ADDENDUM NO. 2

September 19, 2025

VALE FACILITY ADDITION/RENOVATIONS AND MAINTENANCE/IT FACILITY PROJECTS

Addendum Two (AD.02) to the drawings and specifications prepared by Gibraltar Design for **Valparaiso Vale Facility Addition/Renovations and Maintenance/It Facility and Related Work** for Valparaiso Community Schools, Valparaiso, Indiana.

UNIT "A" PLUMBING FIRST FLOOR PLAN

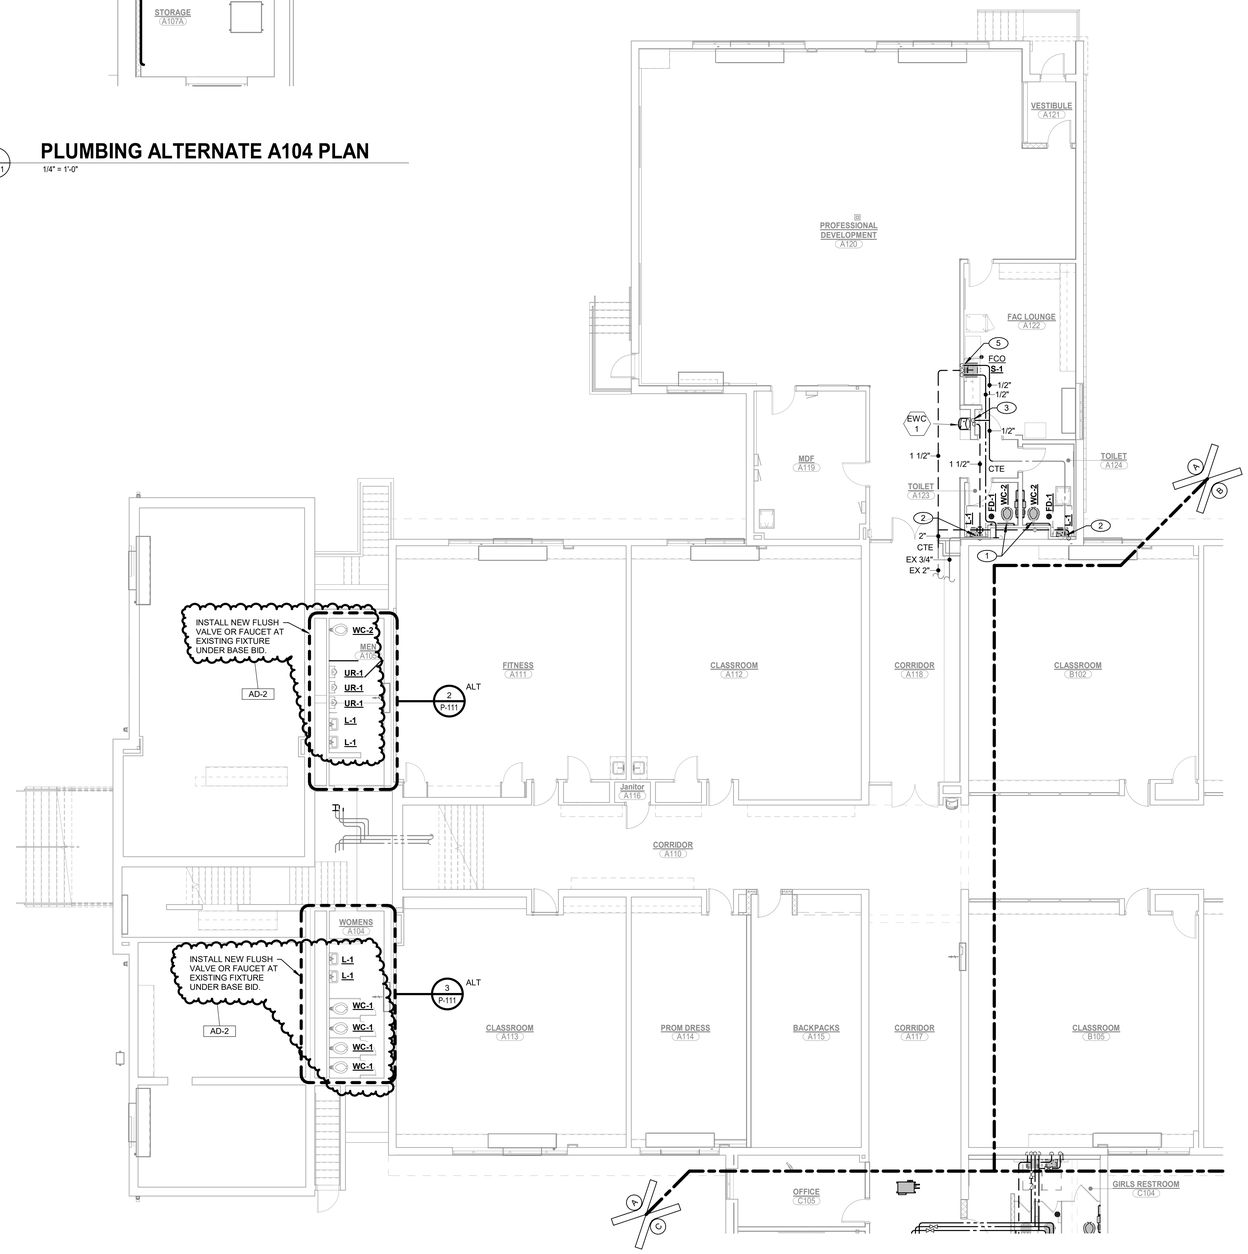
A. Refer to revised, full-size drawing, included in this Addendum, for revisions below.
   1. Revised base bid scope in rooms A104 and A105.

UNIT "B" PLUMBING FIRST FLOOR PLAN

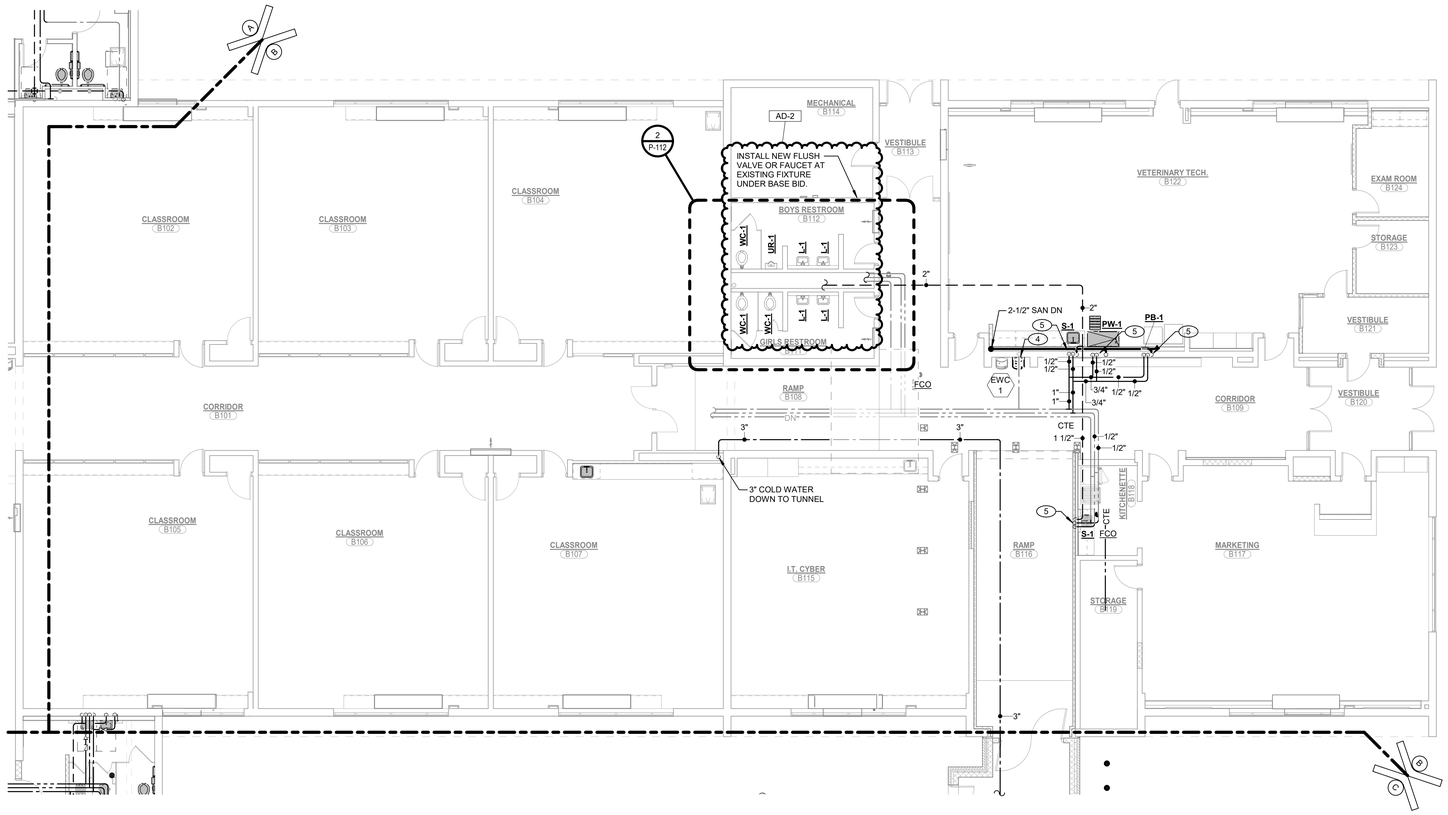
A. Refer to revised, full-size drawing, included in this Addendum, for revisions below.
   1. Revised base bid scope in B111 and B112.

1 P-203 **UNIT "C" PLUMBING ROOF PLAN**

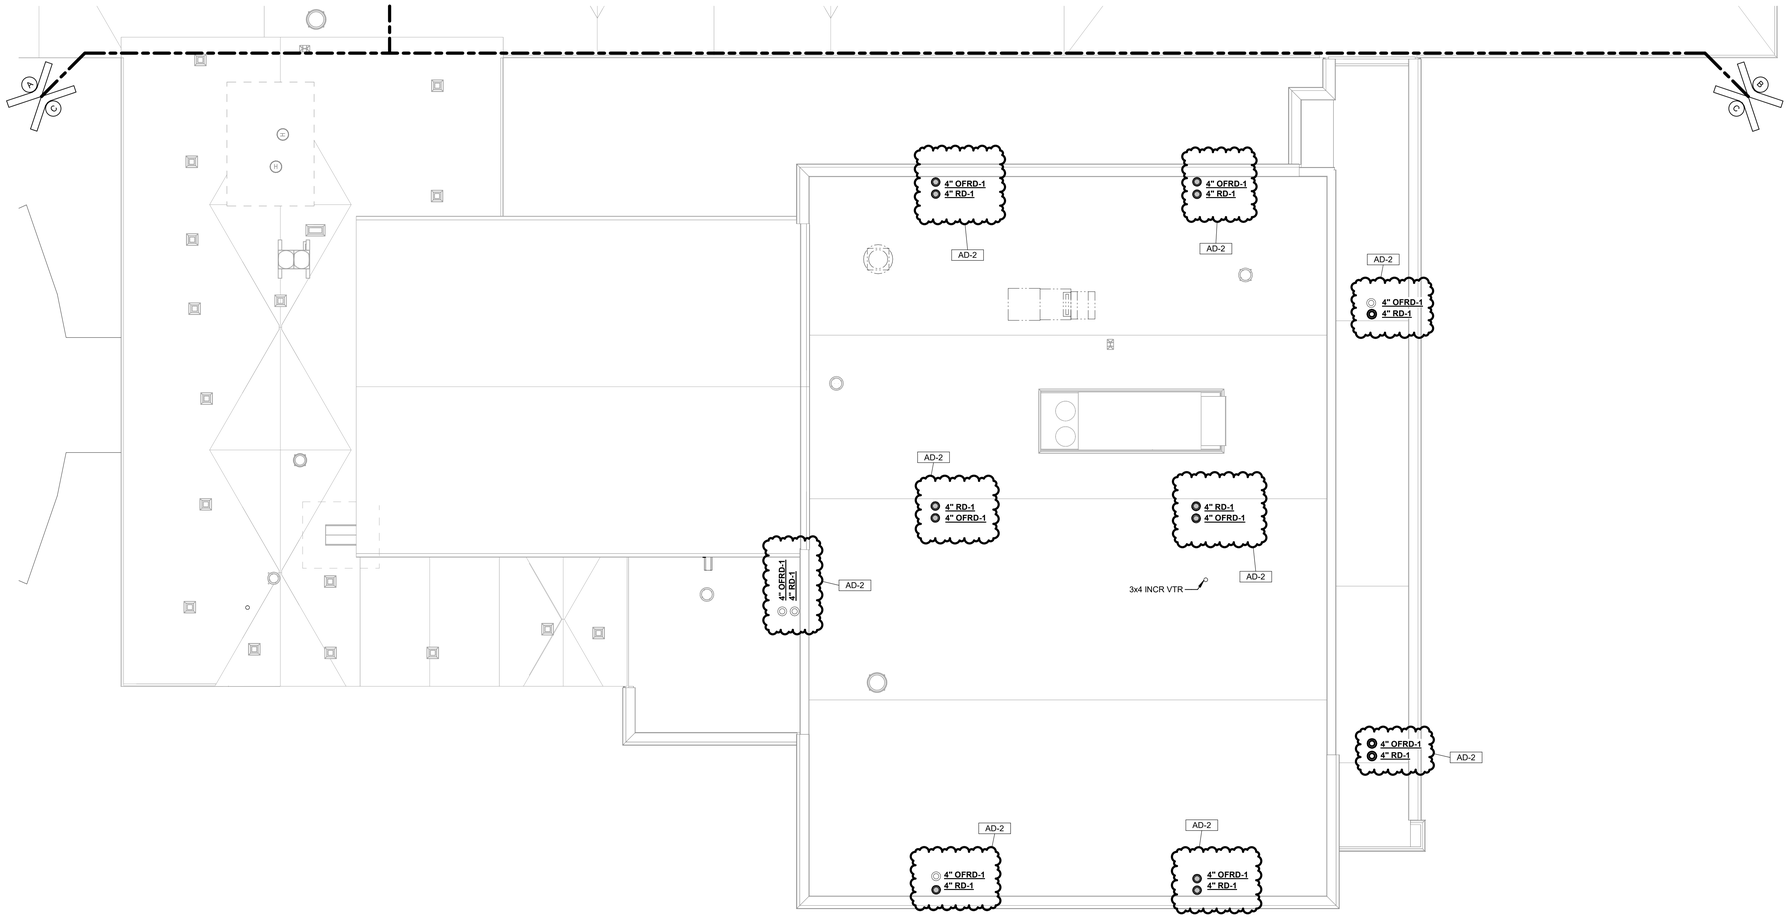
A. Refer to revised, full-size drawing, included in this Addendum, for revisions below.
   1. Revised roof drain layout.

UNIT "A" TECHNOLOGY FIRST FLOOR PLAN

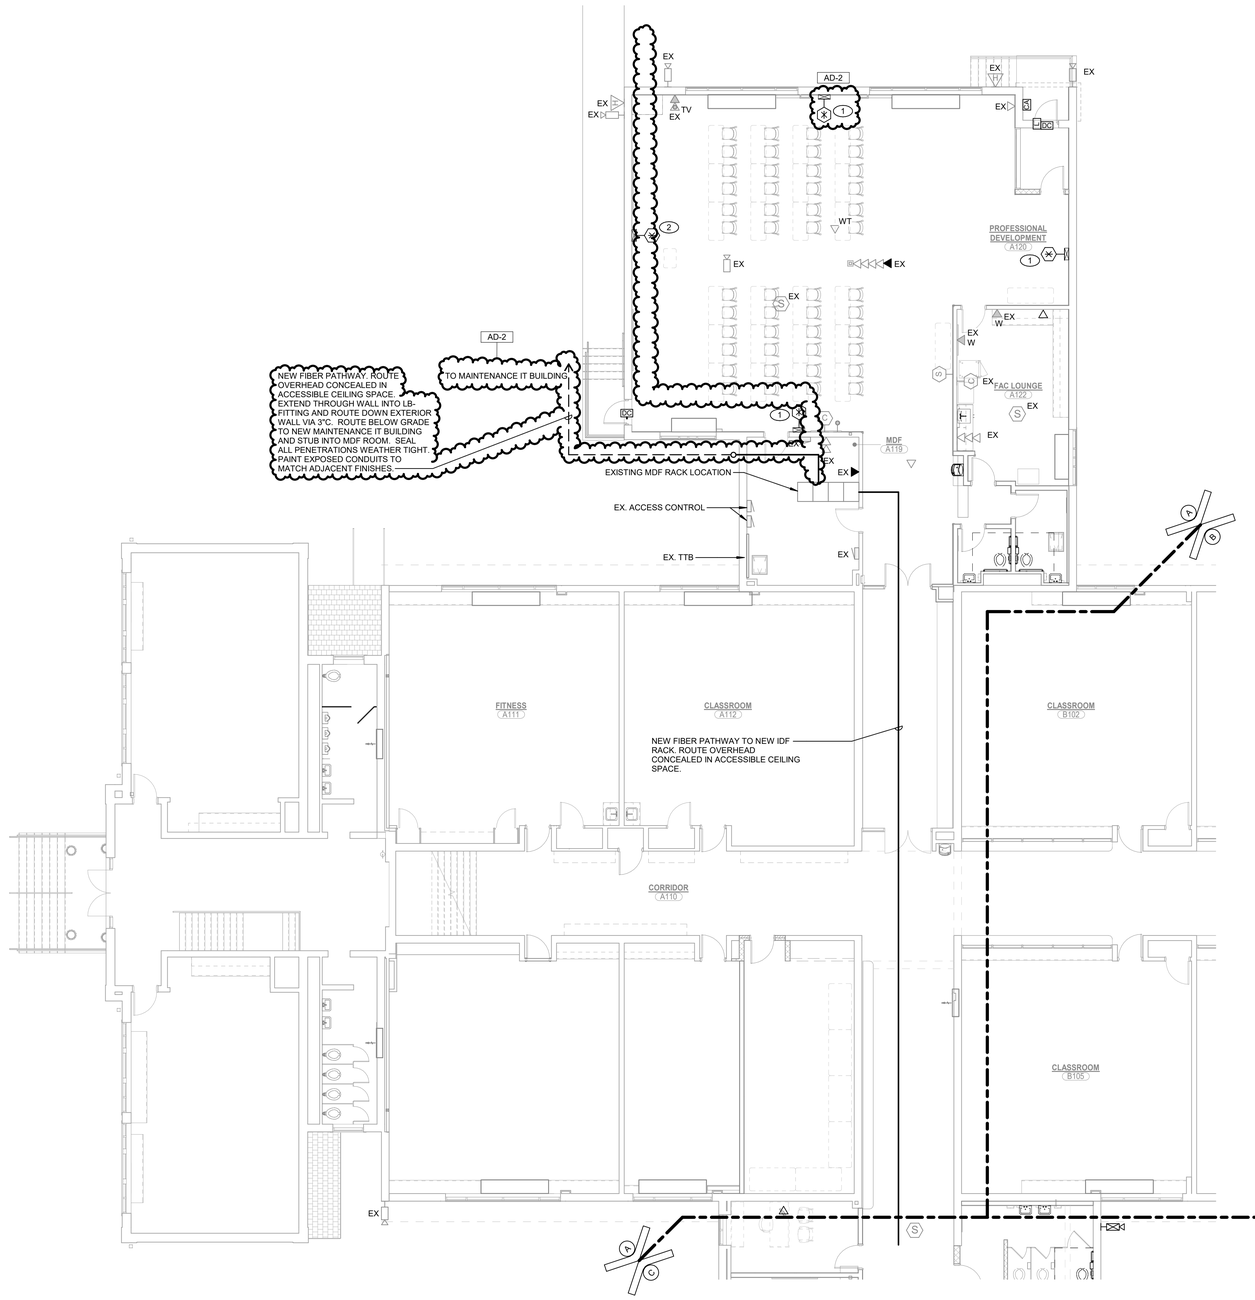
A. Refer to revised, full-size drawing, included in this Addendum, for revisions below.
   1. Revised low voltage fiber pathway.
   2. Added a projector input station.

UNIT "B" TECHNOLOGY FIRST FLOOR PLAN

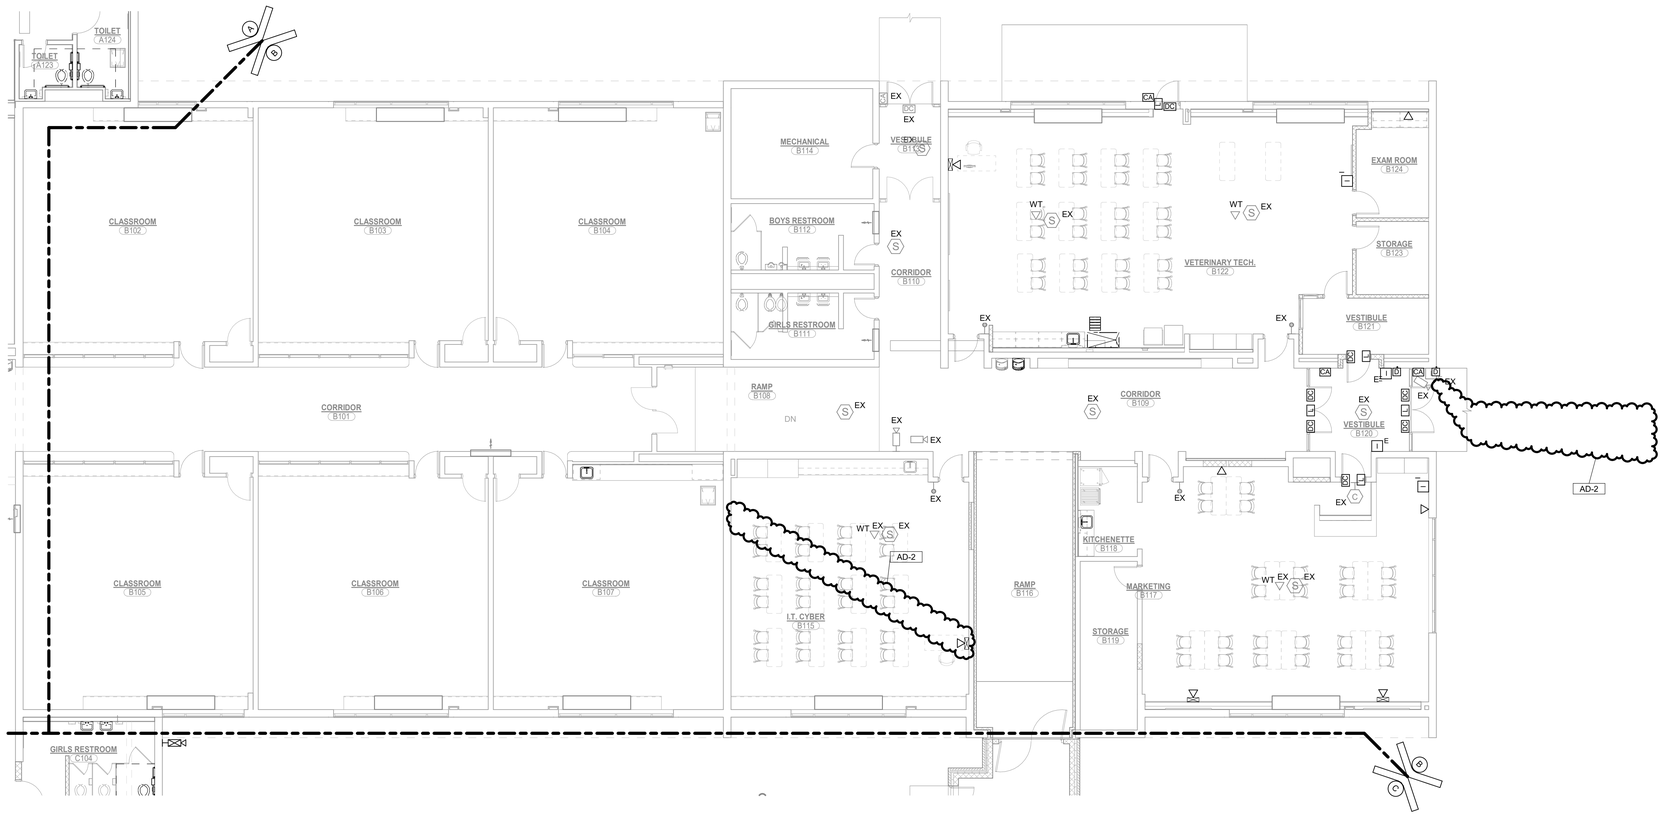
A. Refer to revised, full-size drawing, included in this Addendum, for revisions below.
   1. Removed exterior intercom note.
   2. Relocated data outlet in i.t. cyber b115.

1 T-103 **UNIT "C" TECHNOLOGY FIRST FLOOR PLAN**

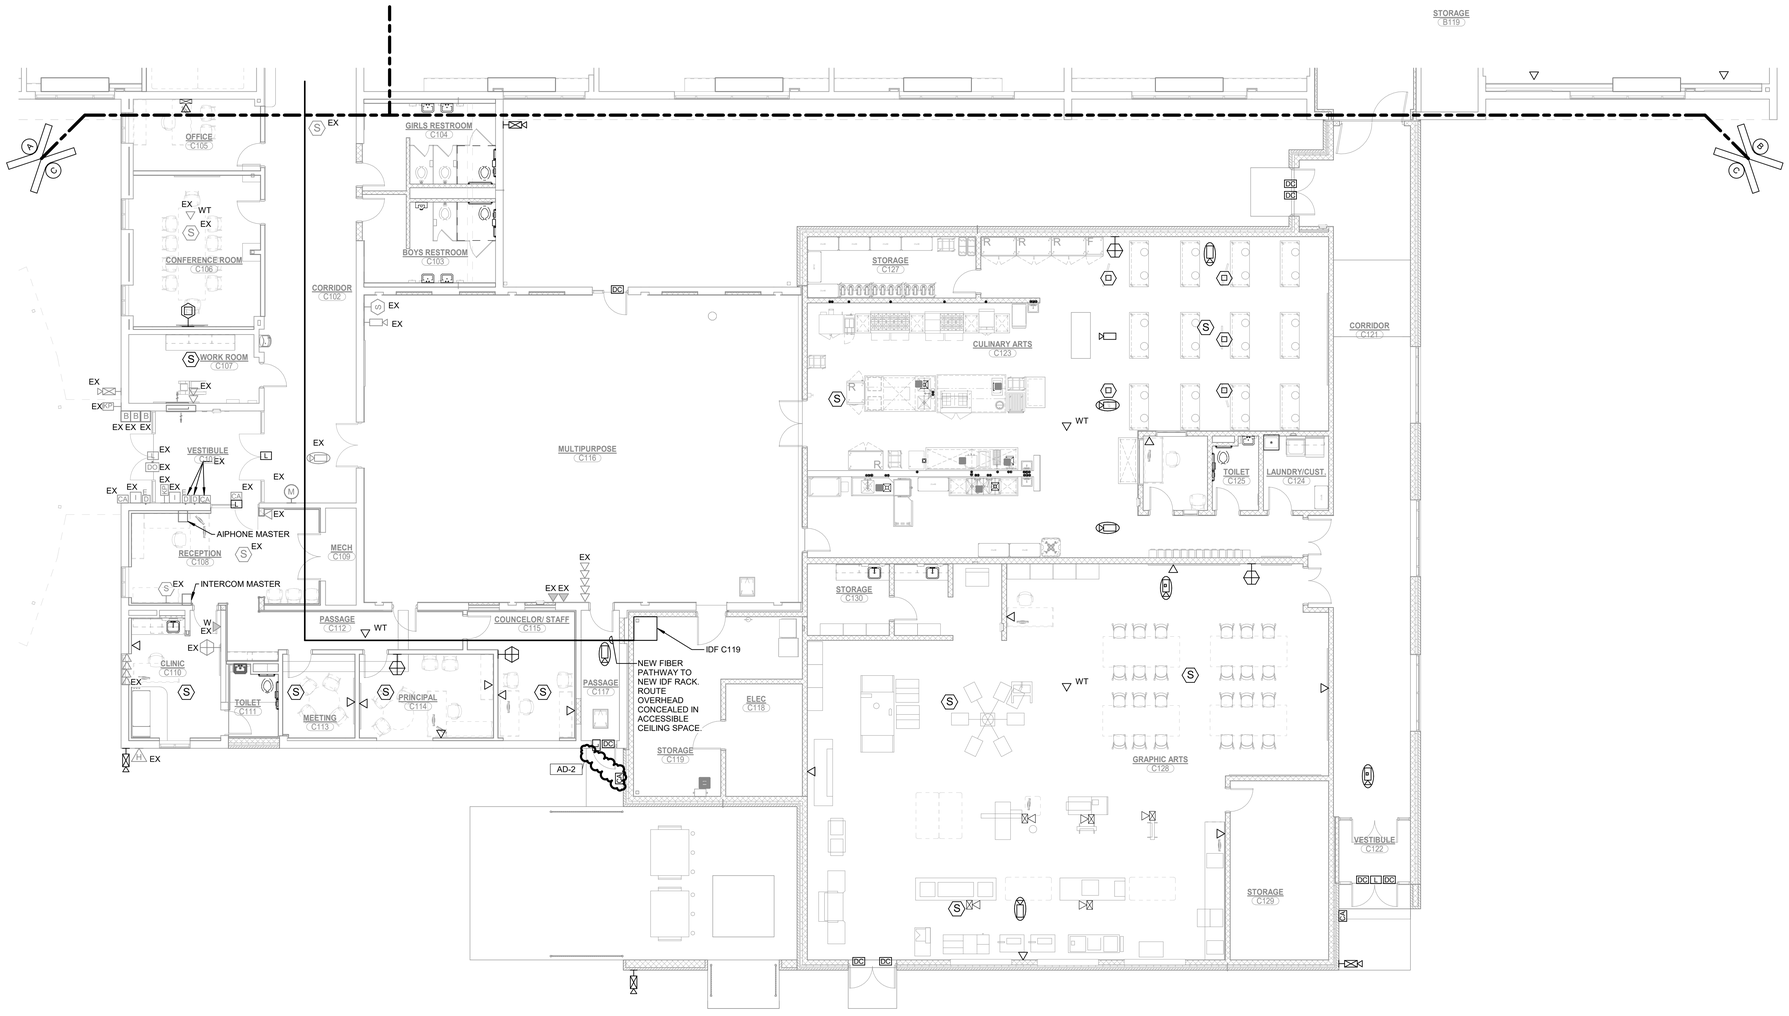
A. Refer to revised, full-size drawing, included in this Addendum, for revisions below.
   1. Relocated exterior card access.
